**ED BELL CONSTRUCTION COMPANY**POST OFFICE BOX 540787  
DALLAS, TEXAS 75354-078710605 HARRY HINES  
DALLAS, TEXAS 75220

Mr. James C. Pierce, Jr., P.E.  
Assistant City Engineer  
Town of Addison  
P.O. Box 9010  
Addison, Texas 75001-9010Re: Arapaho Road Reconstruction  
Addison Road to Dallas North Tollway  
Town of Addison

Re: Final Billing

COPIES	DATE	NO.	DESCRIPTION
1			Partial Paving Plan @ Sta 57+50±

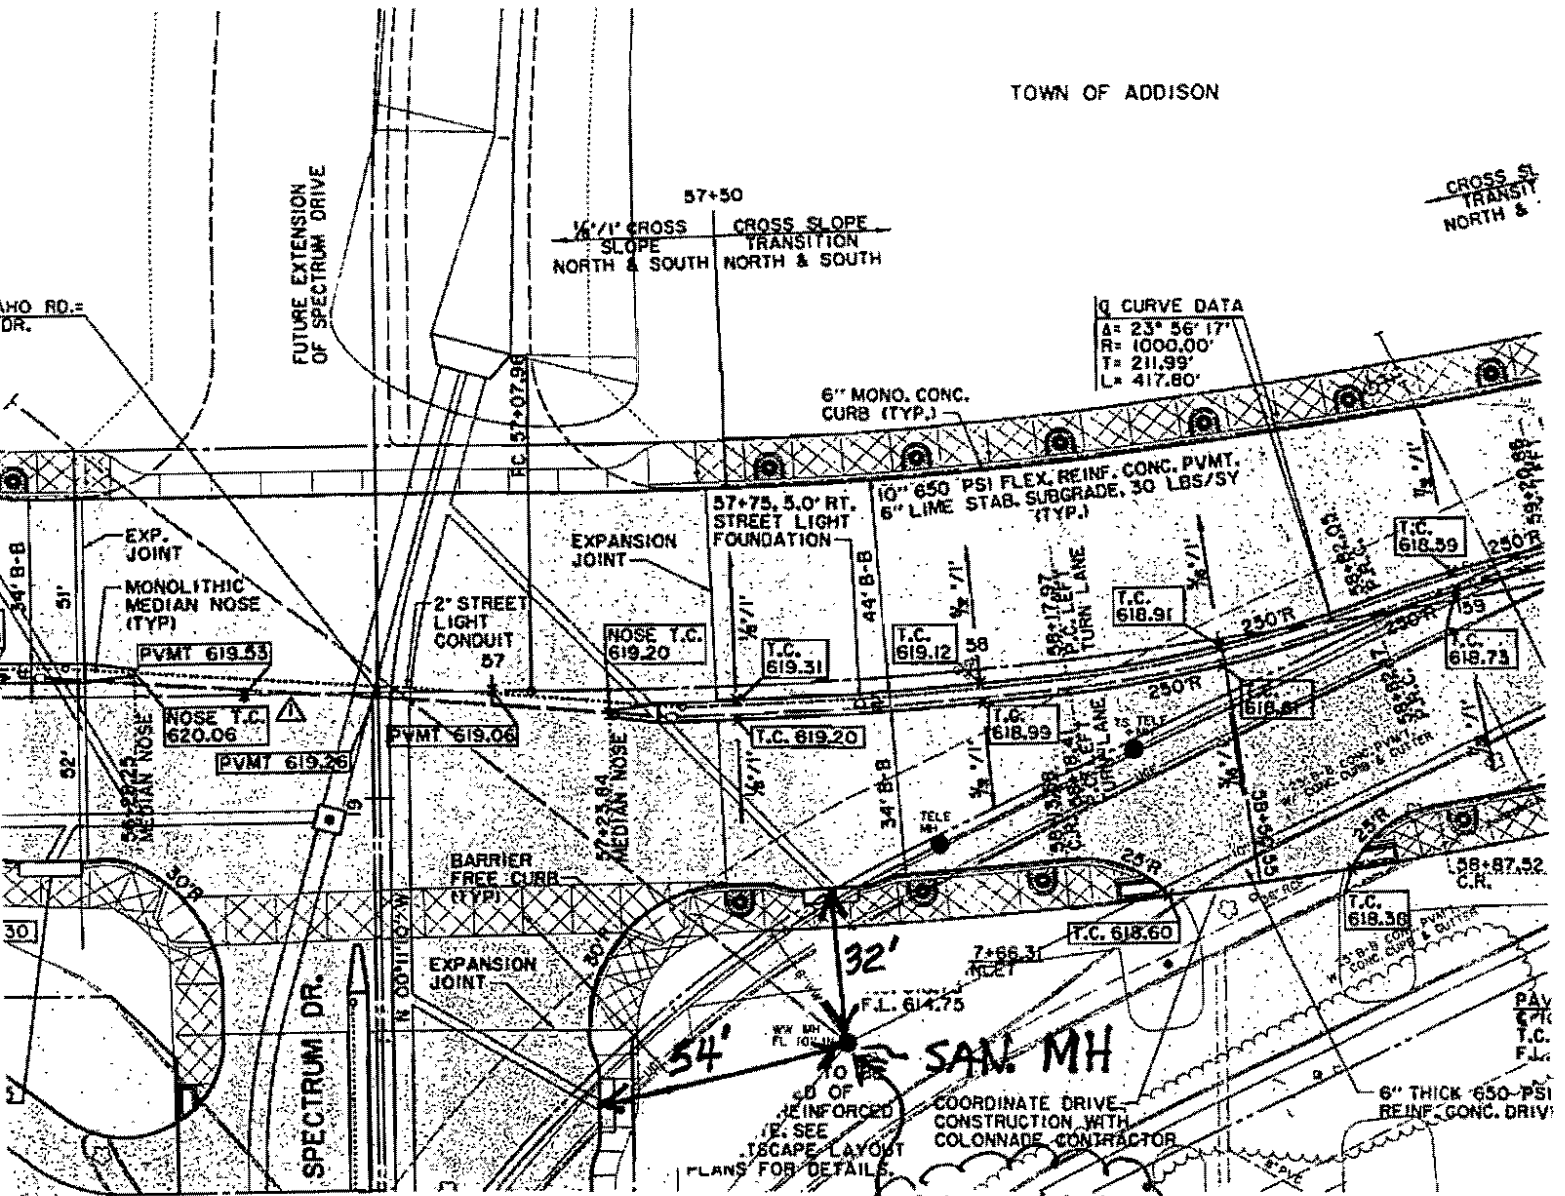
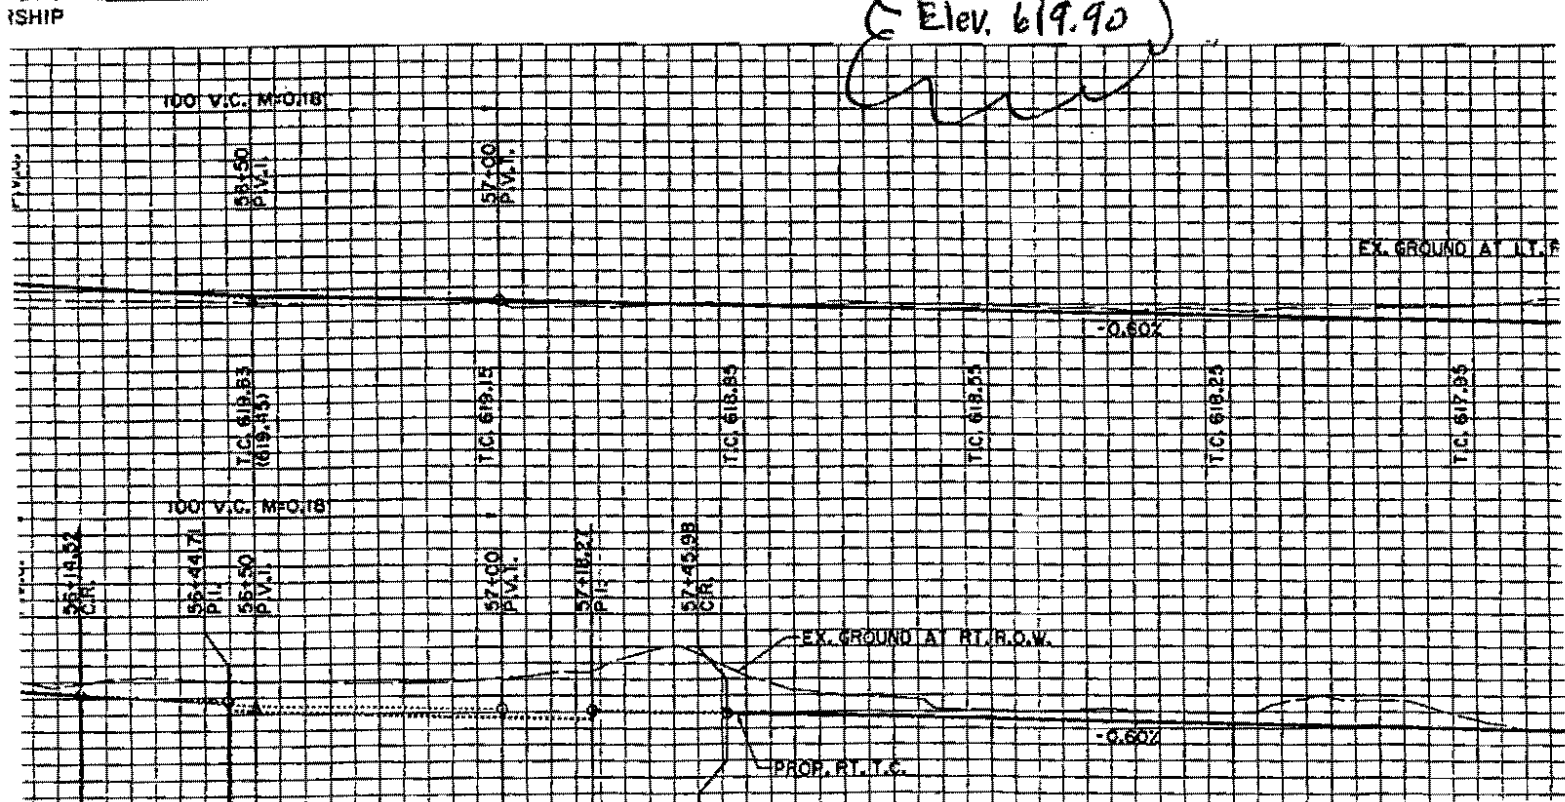
REMARKS Raise Sanitary Manhole lid to Elev 619.90.  
Also, when U-turn is closed we suggest sign wording  
"U-turn Lane Closed Ahead"

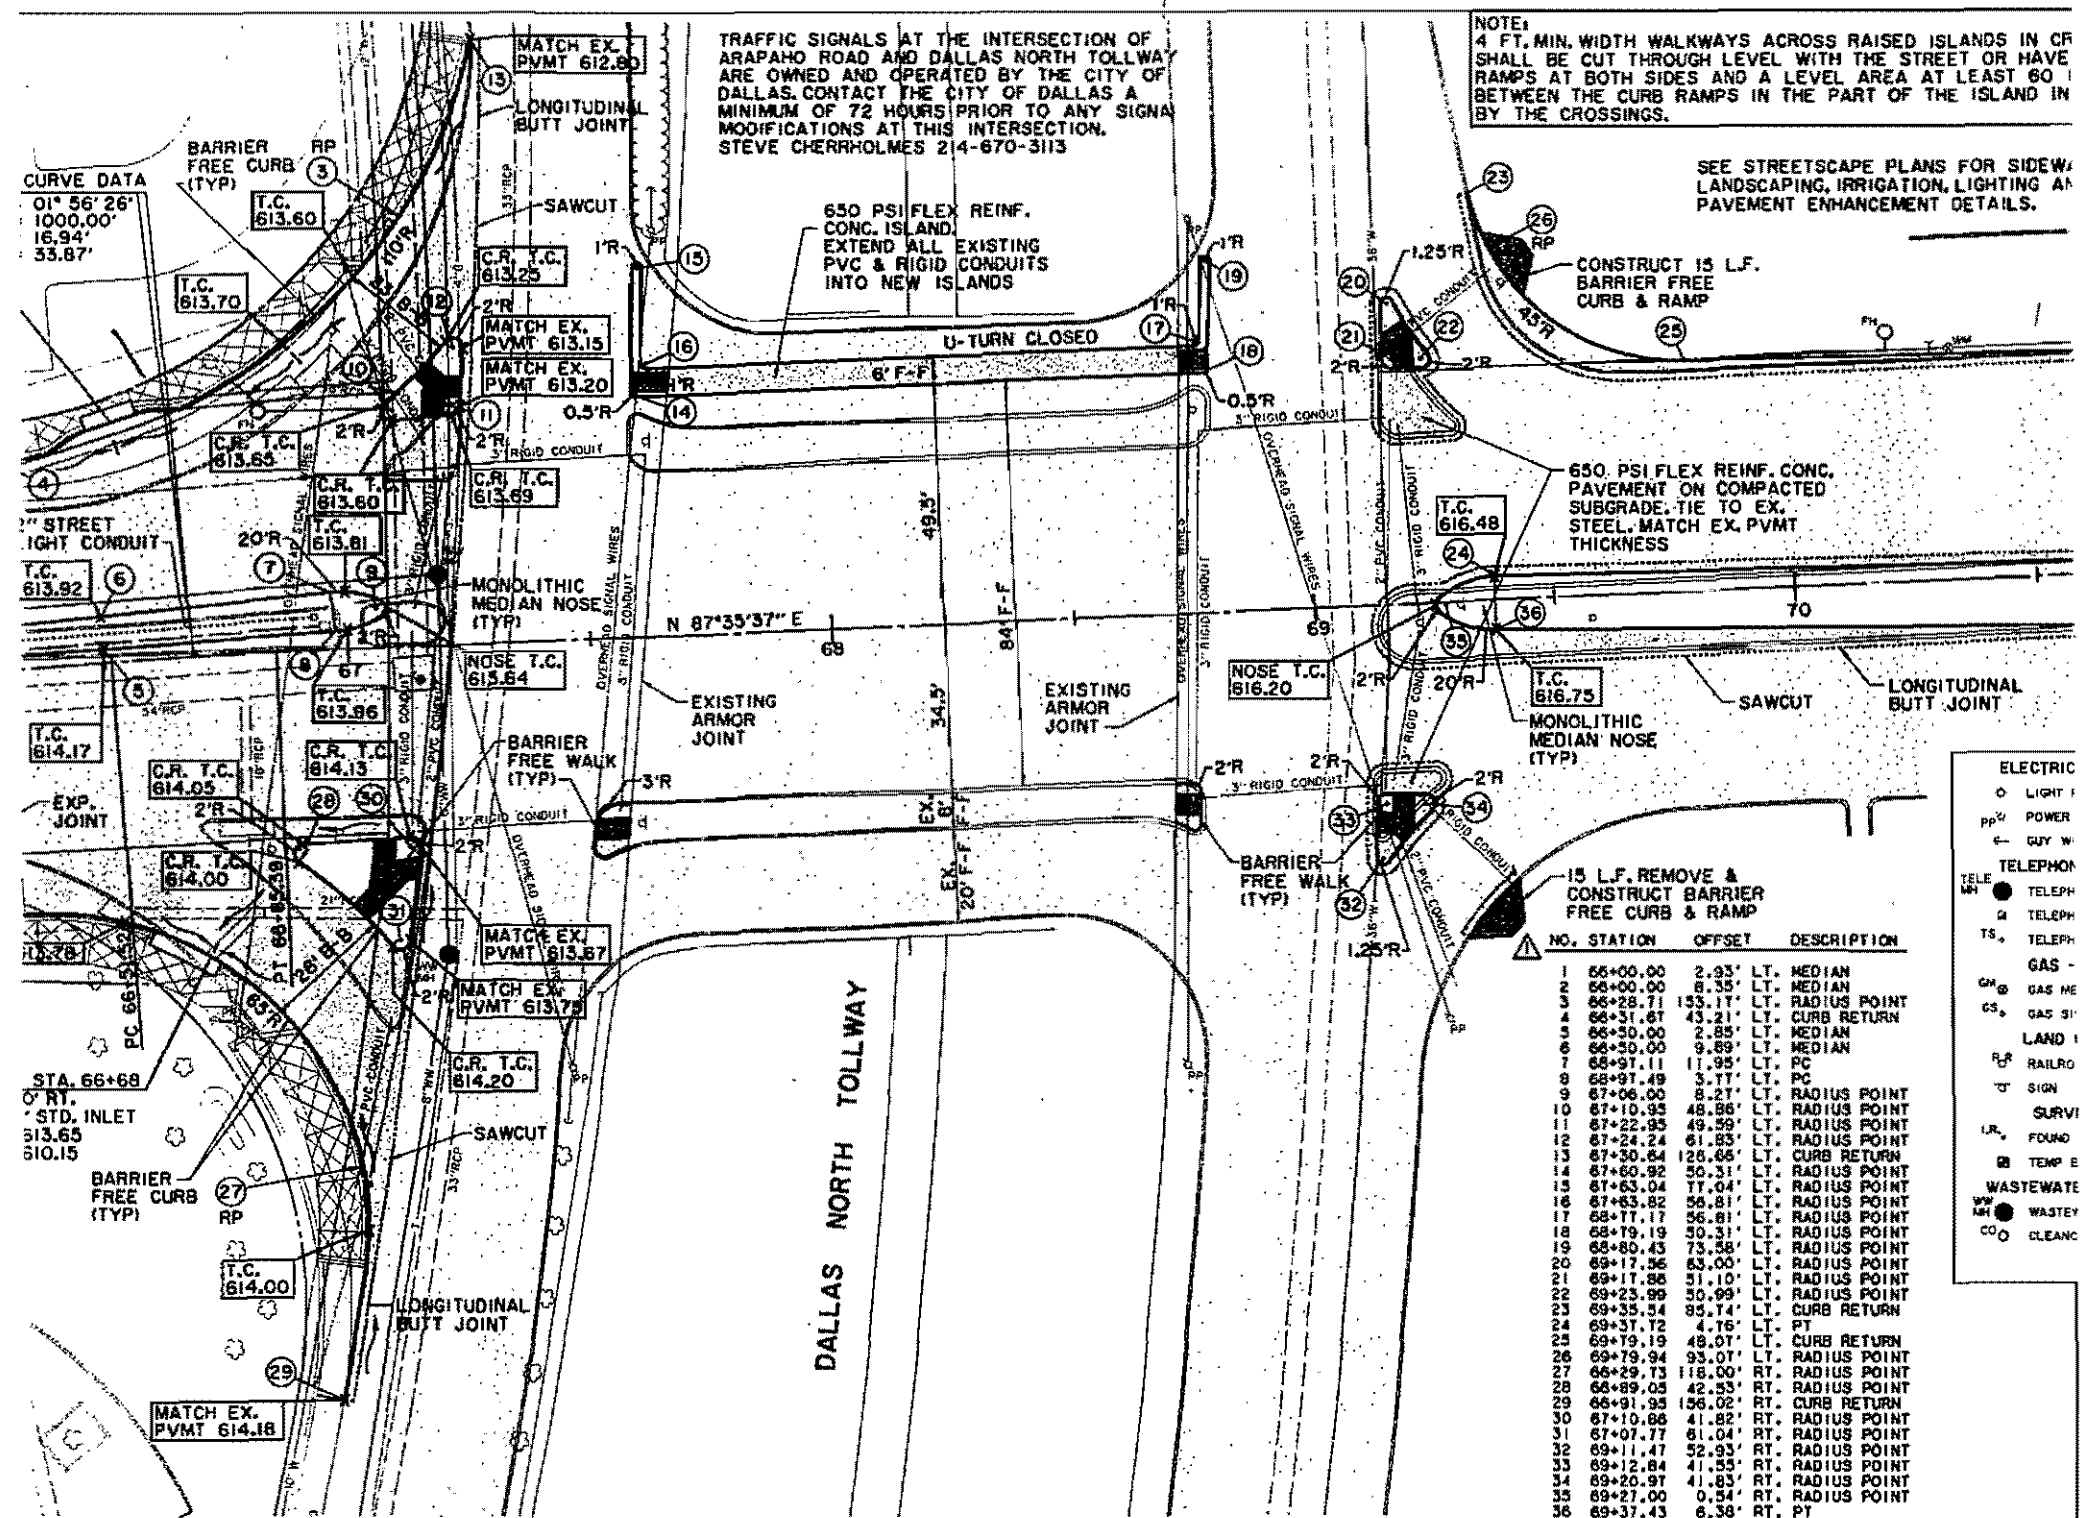
Comments: Joel: We are about to switch traffic at above location. Partial Plan attached. the S.B. to N.B. Uturn is still functional but the concrete island has been removed. We intend to run one lane of traffic east bound and west bound, next to the median, on Arapaho west of the Parkway, for the time being. In about 2-3 months, the road will be open to all lanes.
